Sent: 11/07/2021 3:16:27 PM
266 Whale Beach Road, Whale Beach DA 2021 0419 WRITTEN
Subject: SUBMISSION: LETTER OF OBJECTION AMENDED PLANS 8 July 2021
Submission: Godden
Attachments: GODDEN #2 Submission July 21.docx;

S U B M I S S I O N : G O D D E N
a written submission by way of objection to DA 2021/0419

Re:
266 Whale Beach Road, Whale Beach
DA 2021 0419

WRITTEN SUBMISSION: LETTER OF OBJECTION AMENDED PLANS 8 July 2021
Submission: Godden

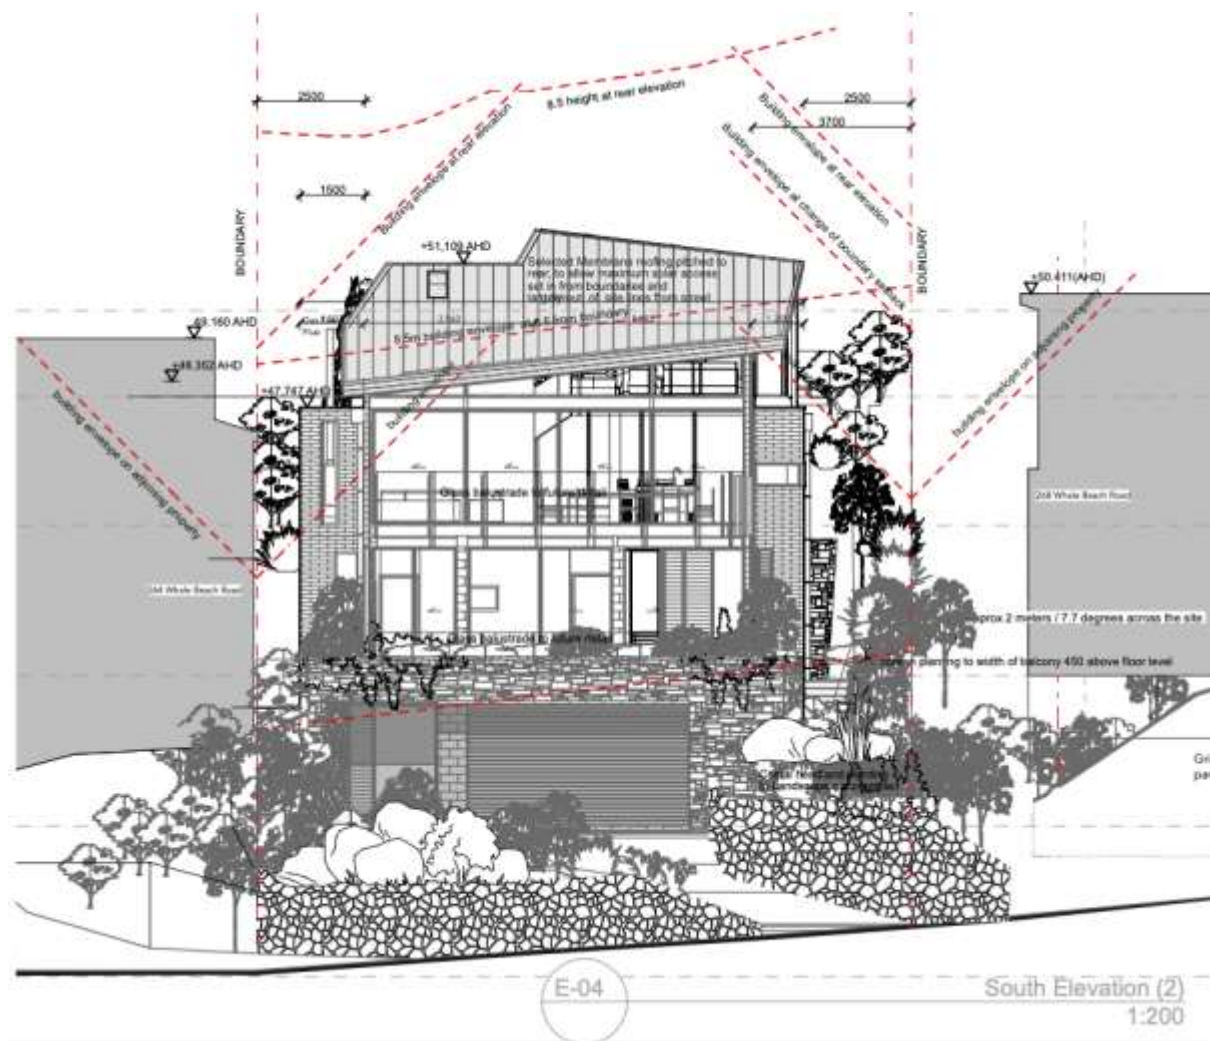
Our main concern stems from the inappropriate building separation, that leads to amenity loss. There has been no consideration on flood control.

In our 19 May Submission, we had asked for the proposed dwelling to be setback within the Side Boundary Envelope at the street elevation frontage. The Applicant has not chosen to take the opportunity to do that within the amended plans, and therefore we ask DDP to refuse this DA.

The Southern Elevation, facing the street, makes this matter clearly obvious.

- We ask that the building is shifted 1.5m to the east, to have a western side setback of 2.5m
- We ask that the building be lowered to fit within the D12.8 Building Envelope controls at Grid 2 and Grid 4, facing our property to the west, and to the neighbour to the east.

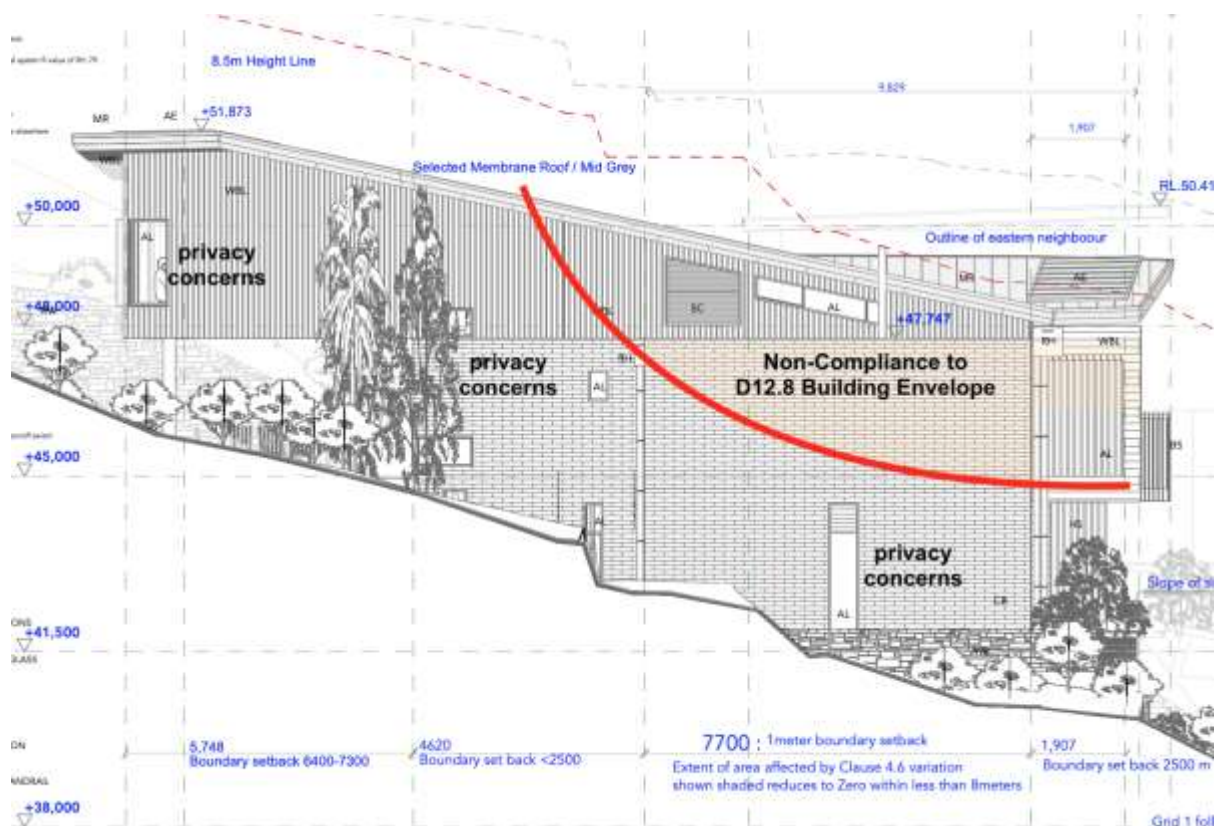
Our concerns are not only our amenity loss, but the wider urban design outcomes, particularly those when viewed from the surrounding streetscape.

The subject site is surrounded by sensitive E4 Environmental Living Low Density Residential environment, with strict building envelope controls that are adhered to and regularly enforced by Council refusals.

The proposed development in this heavily controlled E4 Environmental Living Low Density zone, exceed building envelope controls and many other controls.

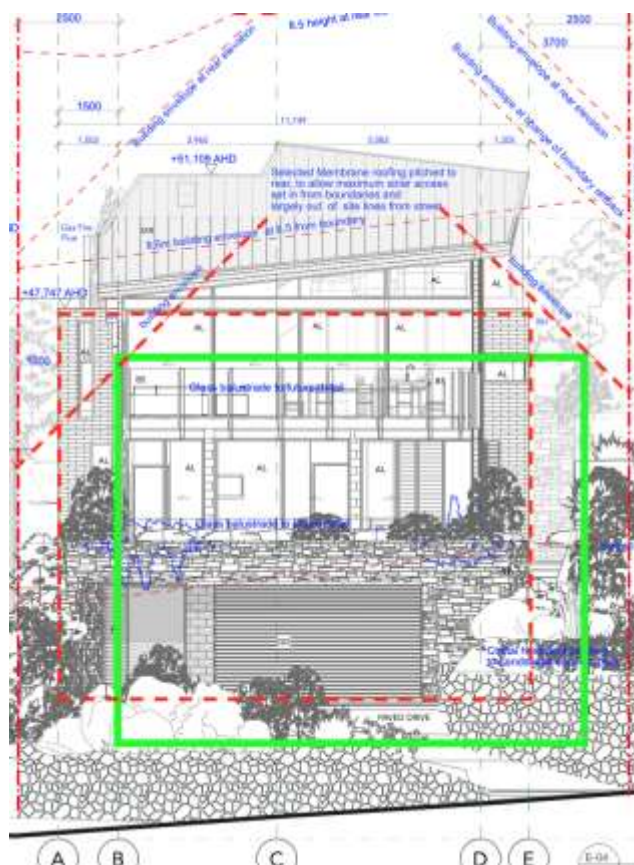
The design unfortunately has not made any attempt to accord with **D12.8 Building Envelope**, and presents a massive non-compliance facing our dwelling, a **massive 2.35m non-compliance**

What the design should have considered within the site analysis is that the land falls steeply with a cross fall, towards our property. The resultant **D12.8 Building Envelope** consideration makes it obvious that the 2.5m side setback should fall to our boundary, to have any chance to begin to comply with the envelope that is being proposed, being a four-storey envelope onto the street.

To achieve better compliance to **D12.8 Building Envelope**, the front elevation should have been positioned to fall within the envelope 45-degree angles, and for a new build development that is easy to achieve. We attach a sketch showing that the proposed development would need to have a 2.5m side setback facing our boundary, and the entire volume of the building reduced to fit within the envelope control.

We attach the sketch showing in 'dotted red square' the proposed envelope at the street frontage, and in 'green' the required amended position. The amendments required:

The reduction of height has the added advantage to the Owner, as the access to the house would have a slower ramped grade to the front entry door, avoiding extremely steep 1:4.7 grades, making access to the street more achievable for seniors living, and car access easier. The SEE states the main aim was:

This amended plan requirement is a ‘very easy fix’, that can be achieved by the submission of amended plans. The Architect simply needs to adjust the building envelope, down and to the east, and adjust the external works to suit.
